national accelerator laboratory

SHAPE OF GRADIENT MAGNETS FOR 200-GEV ACCELERATOR

May 4, 1967

Fig. 1. Cross-section of H-magnet.

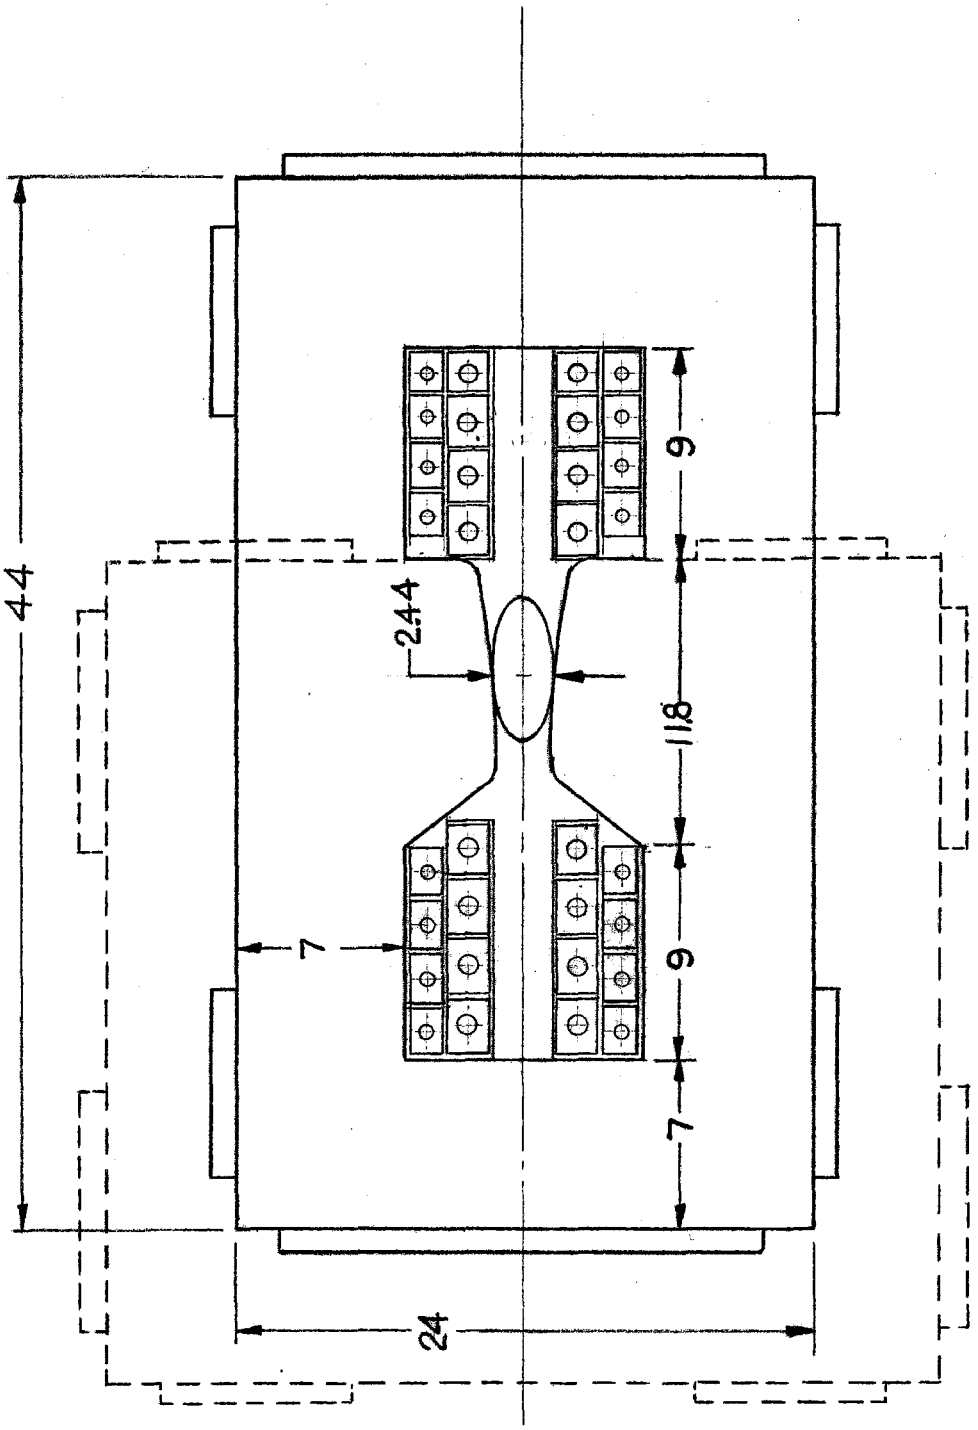
The factors leading to the choice of a "C"-shaped iron core for the gradient magnets of the 200-GeV ring are given in Chap. V of the "200-BeV Design Study".[1] In my opinion this choice should be reconsidered; an "H"-shaped core is technically superior and of lower cost.

A sketch of an H-magnet section with the same pole-face dimensions as used for the C-magnet is shown in Fig. 1. The laminations are die-stamped and held together with longitudinal bars welded to the laminations and stainless steel endplates. The coils will be wound in four layers which can be installed through the gap between pole faces. Coils will have the same total copper cross-section as for the C-magnet; the coil window is enlarged relative to the C-magnet for this purpose.

If further study confirms these conclusions and estimates, I recommend that the gradient magnet cores be changed to the H-shape.
